PLANNING REPORT

Architectural Review Board

25 S. Riverview Street 26-043INF

26-043ARB-INF - 25 S. Riverview

View from S. Riverview

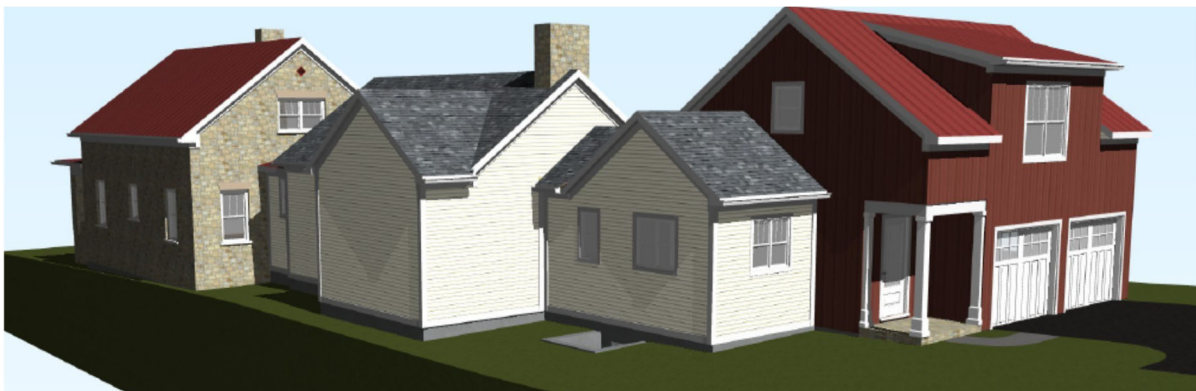
The proposed two-story addition fronts S. Riverview Street. While the addition is set back from the principal façade of the historic structure, its massing is highly visible from the S. Riverview right-of-way. The applicant states that the addition takes cues from the existing house through its overall form and roof design while utilizing differentiated materials and distinct transitions between the historic building and new construction.

Staff has concerns with the proposed two-story addition. Per Code Section 153.173(E), additions to primary structures shall remain subordinate and secondary to the original building. *Historic Design Guidelines* Section 4.12 identifies projecting side

additions that alter the historic building's form and visual prominence as inappropriate. While the Board has previously approved additions that project beyond the historic structure where the design maintained a compatible residential scale and avoided a long, linear mass, staff finds the proposed addition is overly prominent in relation to the existing home. Due to its size, depth, and visibility from S. Riverview Street, the addition becomes a dominant visual element rather than a subordinate extension of the historic structure. Staff recommends exploring a design that reduces the extent of the addition projecting beyond the historic house and relocates larger massing elements farther behind the original structure to better maintain the historic building as the defining feature of the site.

Section 4.12 also recommends that additions remain lower in height than the original building. Although the site slopes upward toward the rear, staff's concern is based on the perceived height and visual prominence of the addition relative to the historic house, rather than solely its

measured height. As shown in the southwest and south perspectives, the two-story portion of the addition appears comparable to, or taller than, the historic structure and competes with its visual prominence. The submitted materials do not adequately demonstrate how existing and proposed grades affect this relationship. Staff recommends providing additional grade information and cross-sections illustrating existing and proposed grades, finished floor elevations, and roof heights at MPR. Regardless of topographic conditions, the two-story portion of the addition should remain lower in height than the historic building and clearly subordinate in appearance to the original house.

- Maintain a one-story addition for portions of the project visible from S. Riverview Street.
- Relocate the taller massing elements behind the historic structure.

- Reduce the height of the addition to better align with *Historic Design Guidelines* Section 4.12, which recommends that additions remain lower than the original building, regardless of topography.
